RESOLUTION NO. 2014-R-03

RESOLUTION OF THE METRO GOLD LINE FOOTHILL EXTENSION CONSTRUCTION AUTHORITY, ADOPTING AN ADDENDUM PURSUANT TO THE CALIFORNIA ENVIRONMENTAL QUALITY ACT AND APPROVING PROJECT REFINEMENTS RELATED TO PHASE 2B OF THE GOLD LINE FOOTHILL EXTENSION, FROM AZUSA TO MONTCLAIR, INCLUDING A BRIDGE CROSSING AT GAREY AVENUE AND RELOCATION OF THE POMONA STATION

Addendum No. 1

**Analyzing a Grade-Separated Crossing at Garey Avenue and a Shift
in the Location of the Pomona Station Platform**

Figure 1. Plan and Profile of Bridge at Garey Avenue

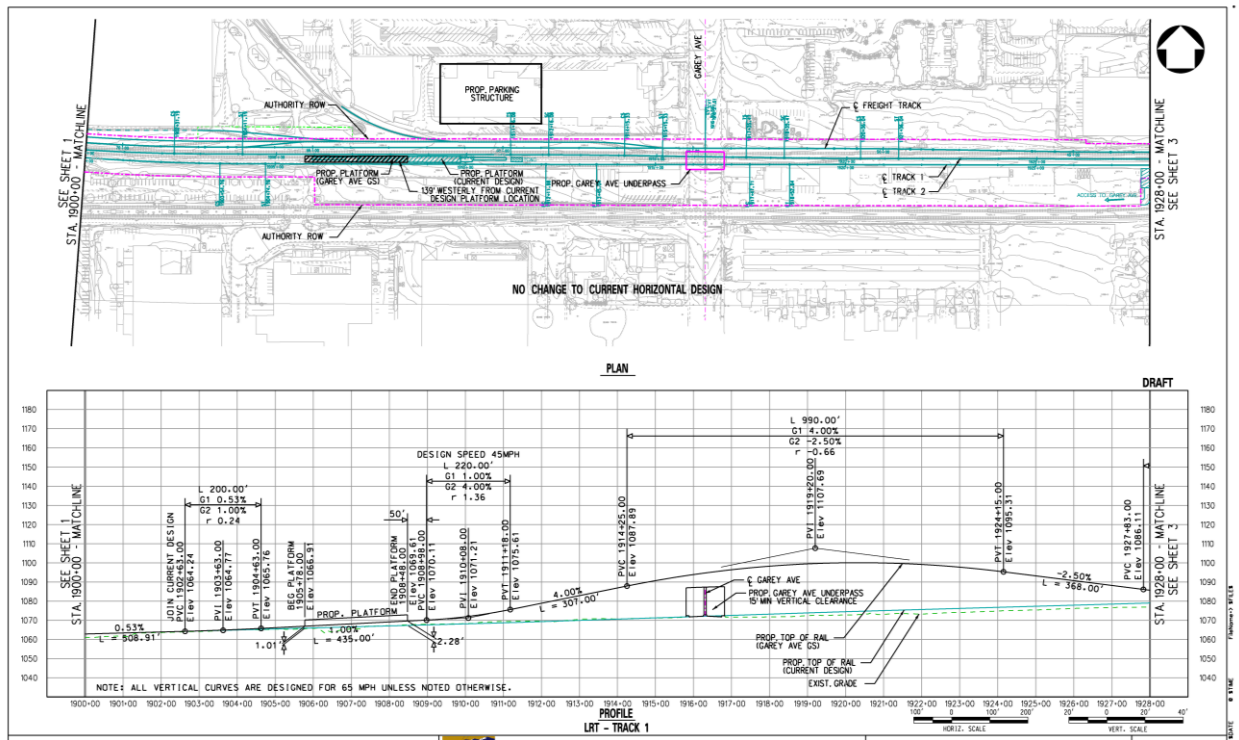
The Authority has analyzed the potential refinement of the track alignment design to include an LRT bridge at Garey Avenue, which would address concerns of the City of Pomona about an at-grade crossing at this location. The length of the grade separation from end to end would be approximately 2,300 feet—spanning from just east of the adjusted station platform to a point approximately 1,500 feet east of Garey Avenue.

Adhering to California Manual on Uniform Traffic Control Devices (MUCTD) standards, the roadway clearance (for vehicles) for the Garey Avenue road below the bridge would be 15 feet and 6 inches.

At Garey Avenue, the bridge would be approximately 27 feet tall at the highest point as measured from the roadway to the top of the barrier, the highest most visible permanent element of the structure. The overhead catenary system (OCS), i.e., the electric wires that power the train and the poles that suspend them, are between 19 and 21 feet above the top of rail. OCS poles, normally spaced 130-140 feet apart, are 24 feet in total height.

Figure 1 shows the plans depicting both the platform location considered in the Final EIR (in green) and the proposed platform location refinement (in black).

Figure 1: Plan and Profile of Garey Avenue LRT Bridge (Page 1)

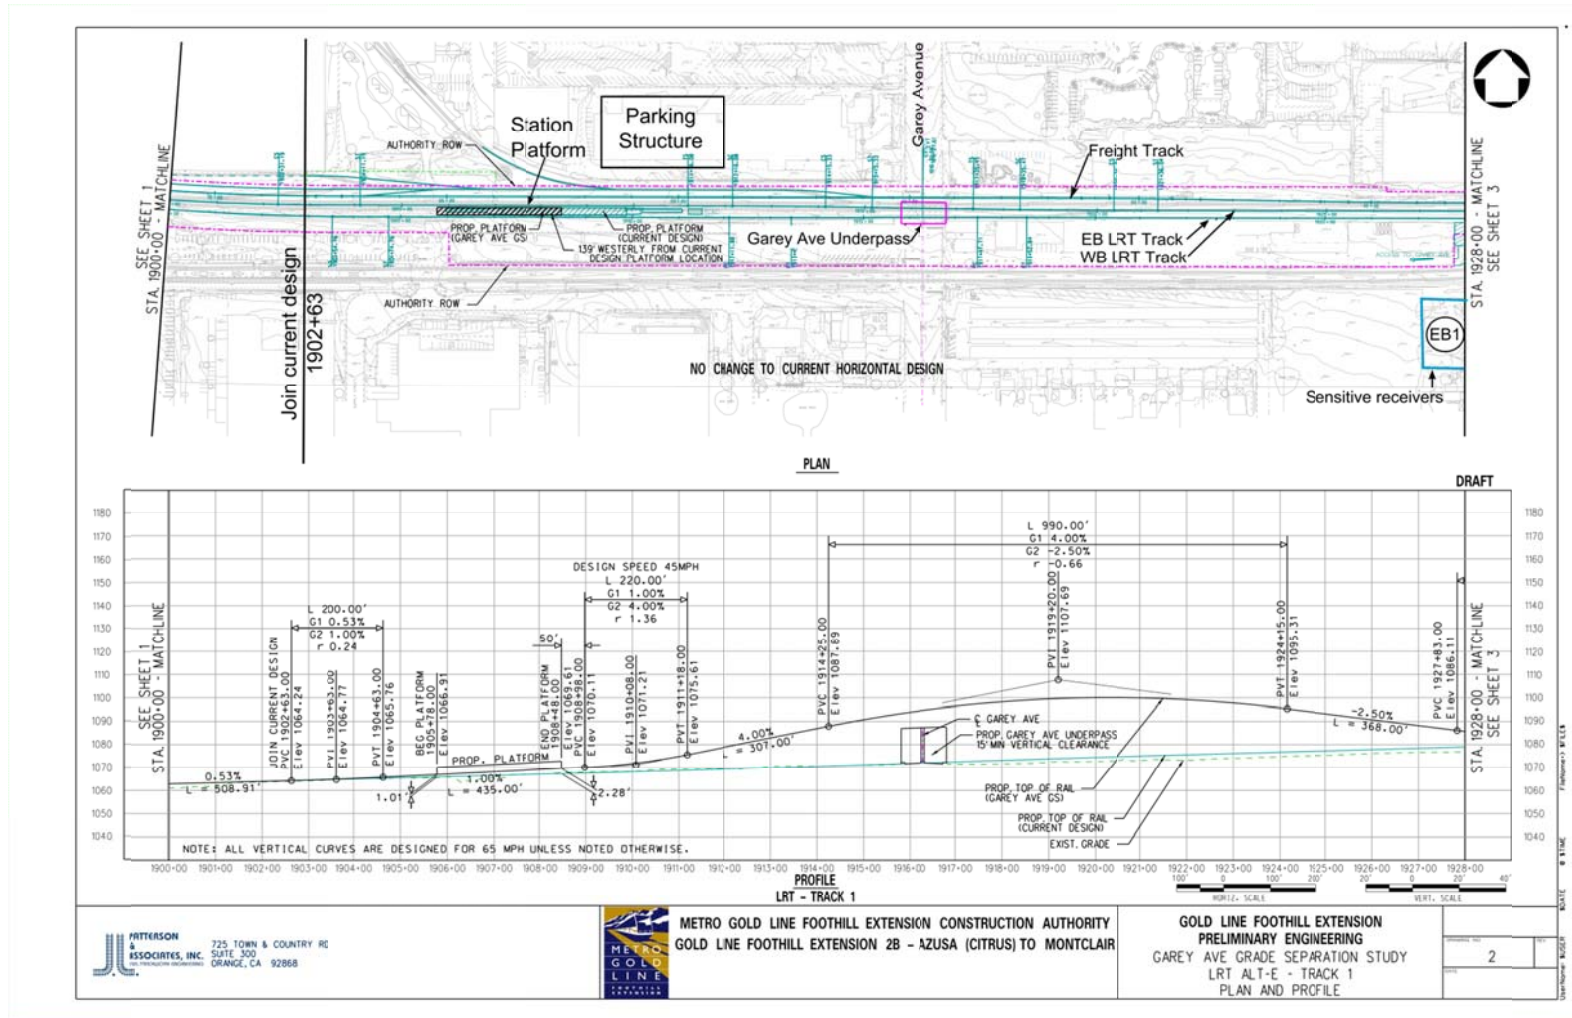
The incorporation of the LRT bridge will result in a vertical change in the track location, but will not result in a horizontal change in the track location. The incorporation of the LRT bridge will also result in a shift of a proposed station platform farther west. The sensitive receivers near the proposed LRT bridge (cluster EB1 in Pomona) are located at the east end of the bridge, where the proposed top of rail will be about 5 feet higher than the proposed top of rail for the Final EIR project. The 5 foot elevation difference does not result in a change in the predicted noise or vibration levels. The predicted noise and vibration levels for both the Final EIR Project and Addendum Project are shown in Table 4. There are no sensitive receivers near the proposed platform for the Final EIR project or for the LRT bridge project, so the shift in the platform location will not result in any changes to the noise or vibration analysis.
